Project: DOUGLAS STATION
LSMO
Issue Date: August 11, 2023

COVER SHEET
Construction Plans for:
Douglas Station Commercial Park
Lee's Summit, Jackson County, Missouri

REVISIONS
REV. 3/7/2024

LANDSCAPE PLAN
Construction Plans for:
Douglas Station Commercial Park
Lee's Summit, Jackson County, Missouri

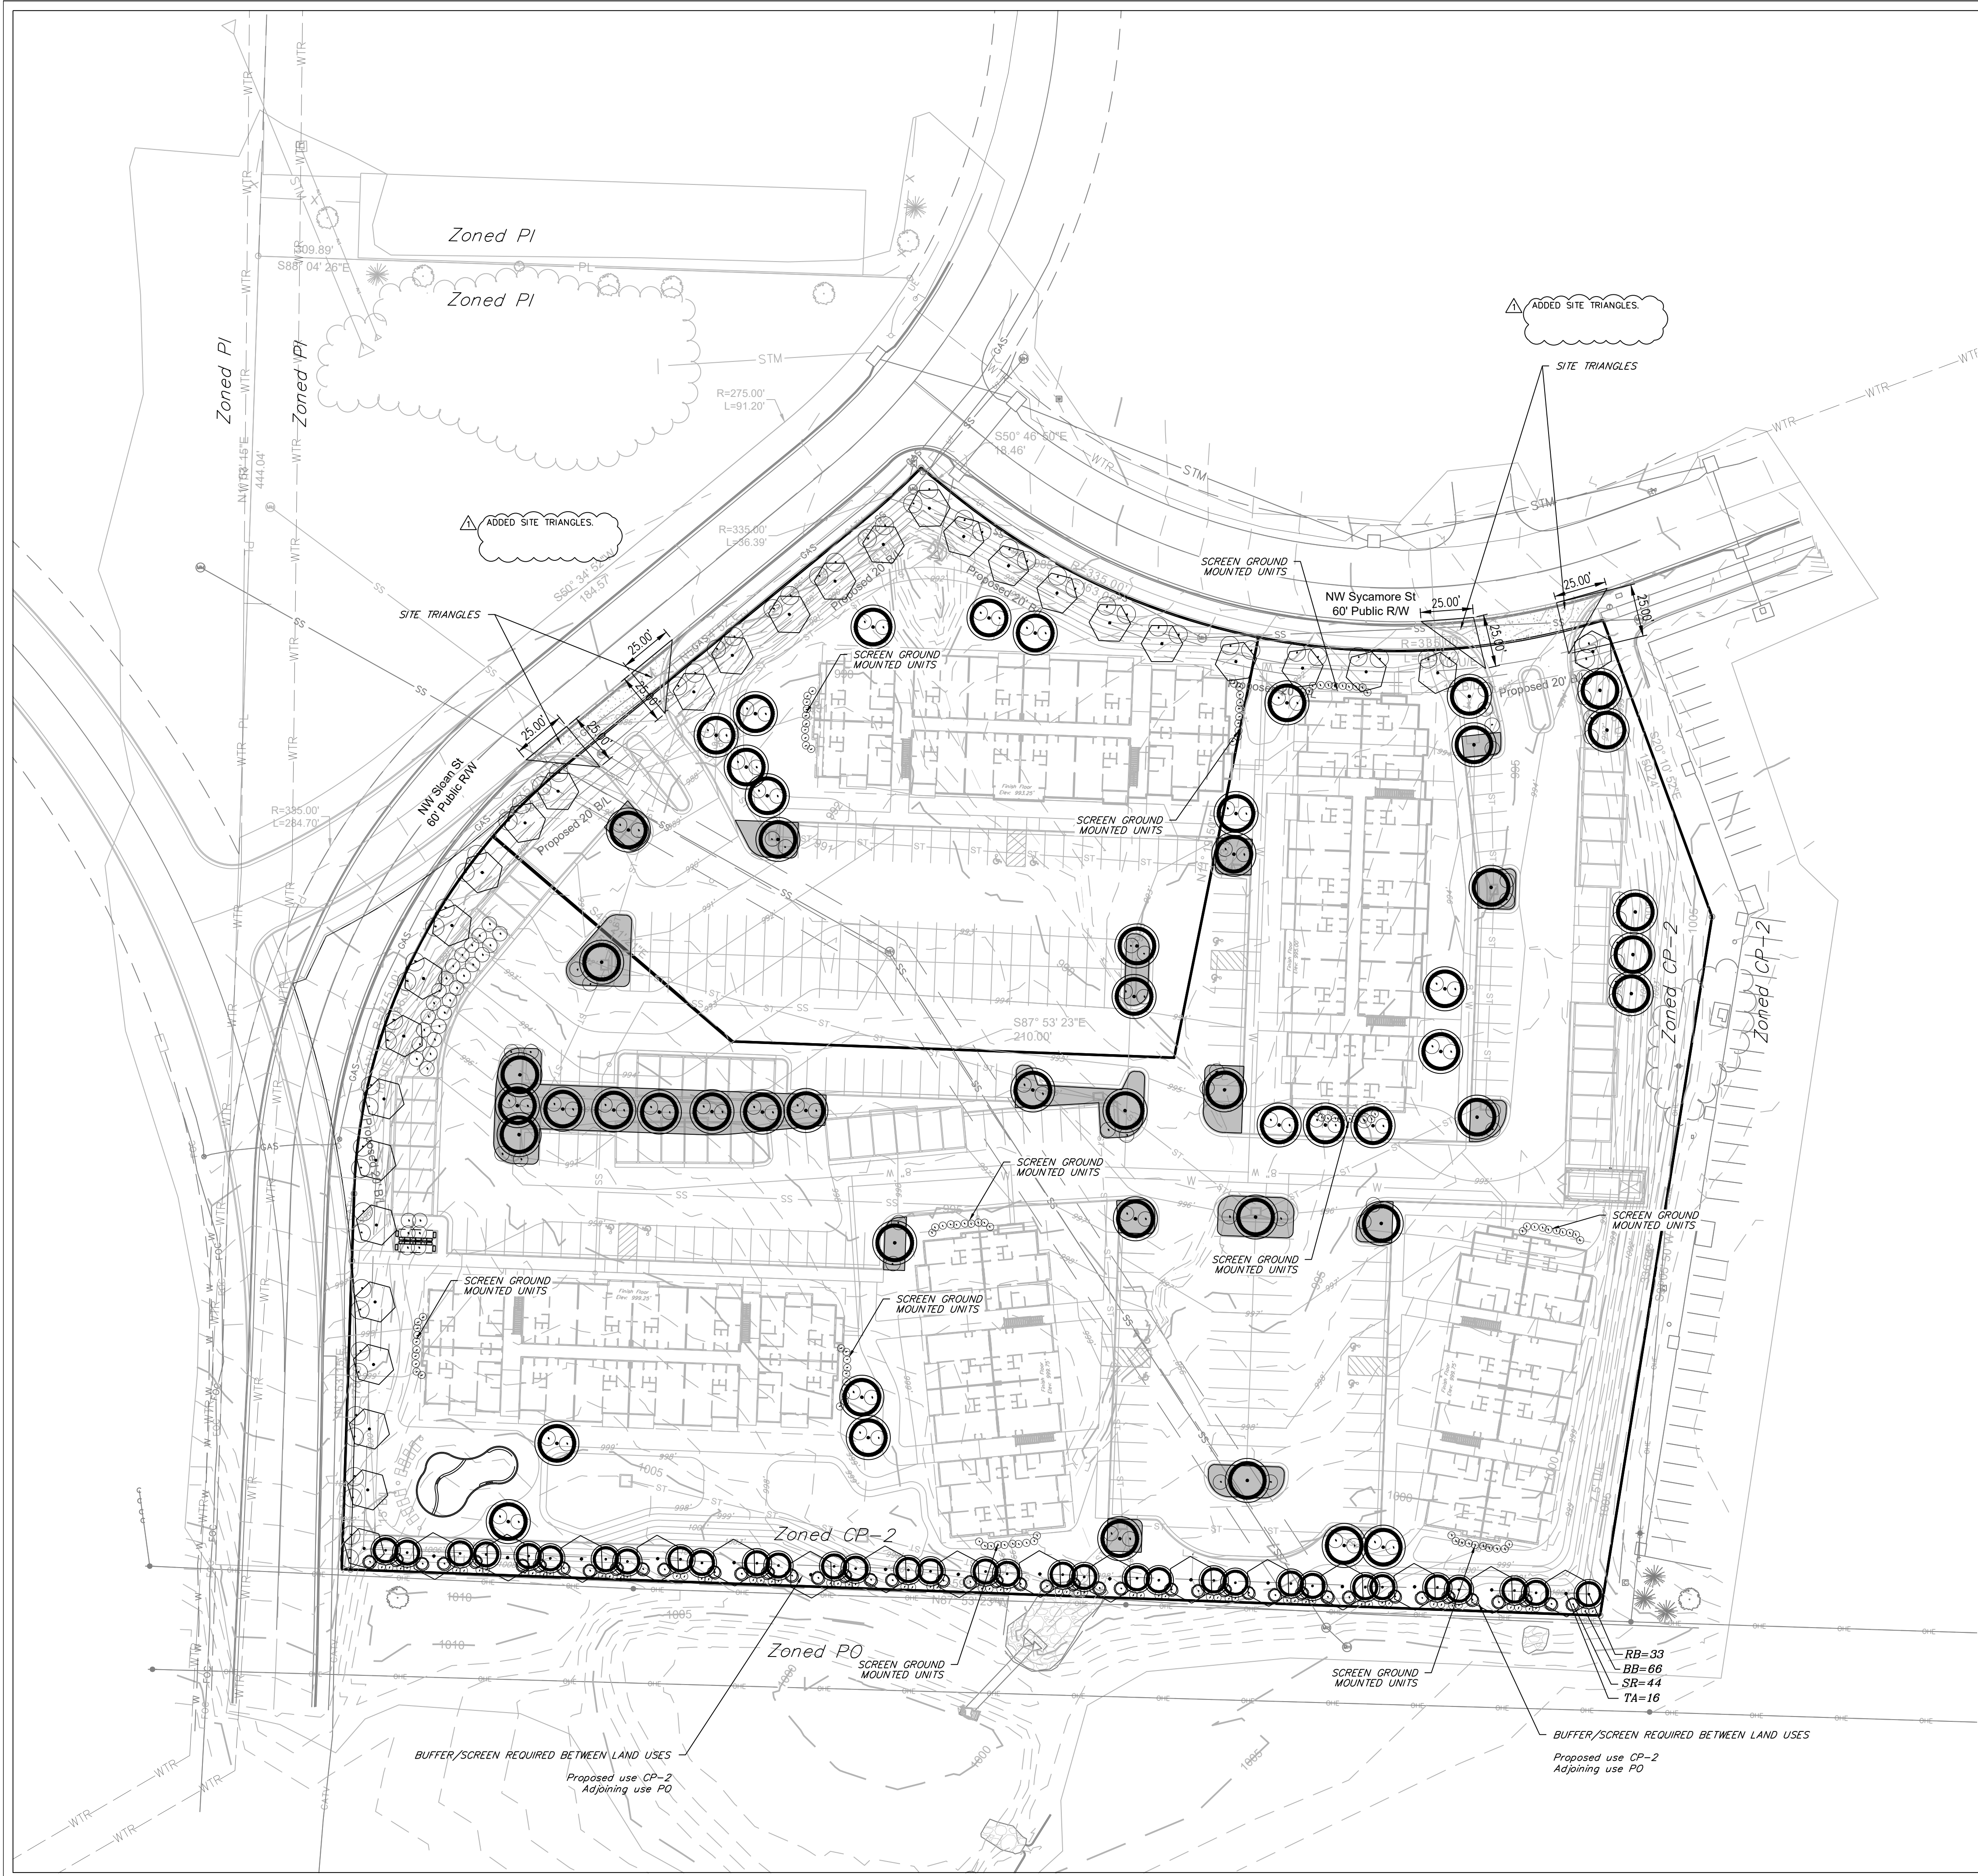
ADDED NOTE.

NOTE:
Areas not covered with other materials shall be covered with sod.
